**County of Loudoun**  
**Department of Planning**  
**MEMORANDUM**

**SUBJECT: ZMOD 2008-0008**  
**Lakeview at University Center Comprehensive Sign Plan-2<sup>nd</sup> Referral**

**SUBJECT: ZMOD 2008-0008**  
**Lakeview at University Center Comprehensive Sign Plan**

**RE: ZMOD 2008-0008, Lakeview at University Center Comprehensive Sign Plan  
2nd Referral Response**

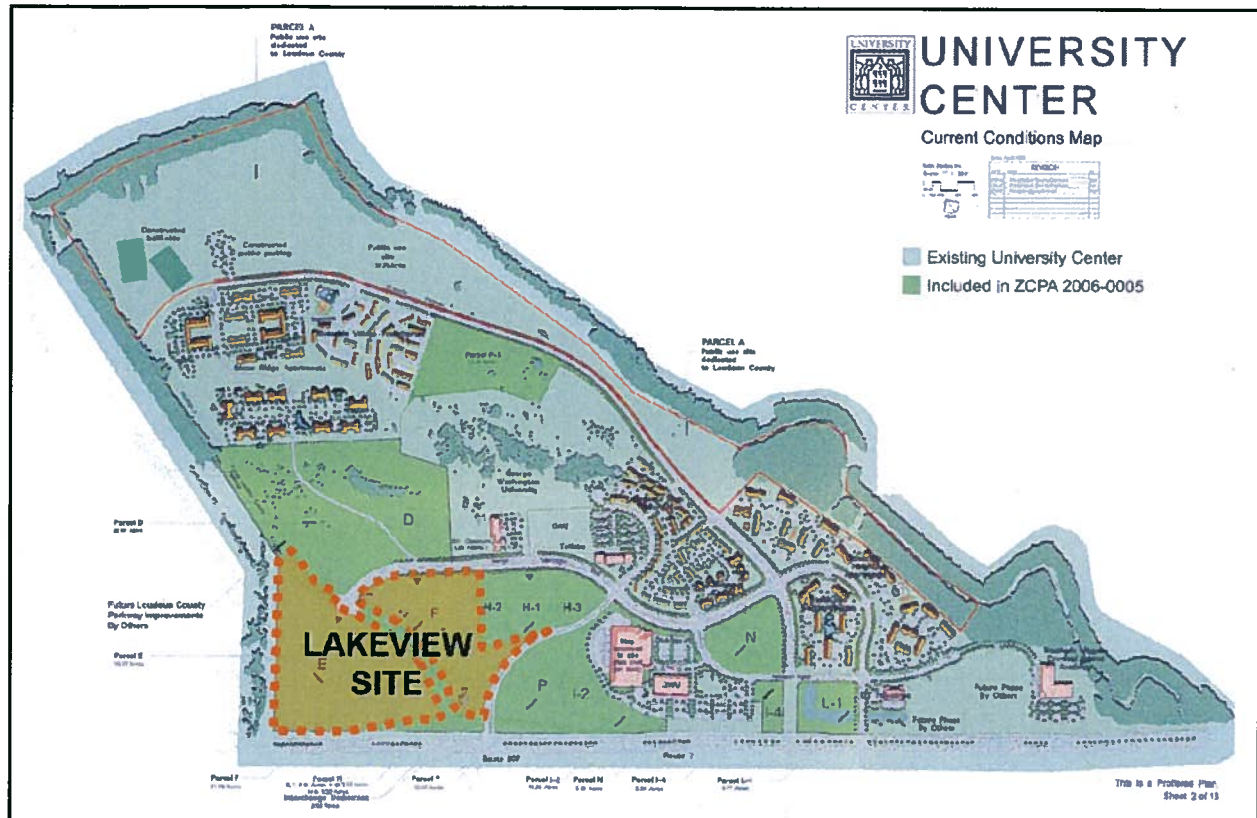
The proposed sign plan proposes detailed regulations for a variety of signage within the Lakeview portion of the University Center project (see map below). It is not clear how the current application relates to existing signage within the larger University Center development.
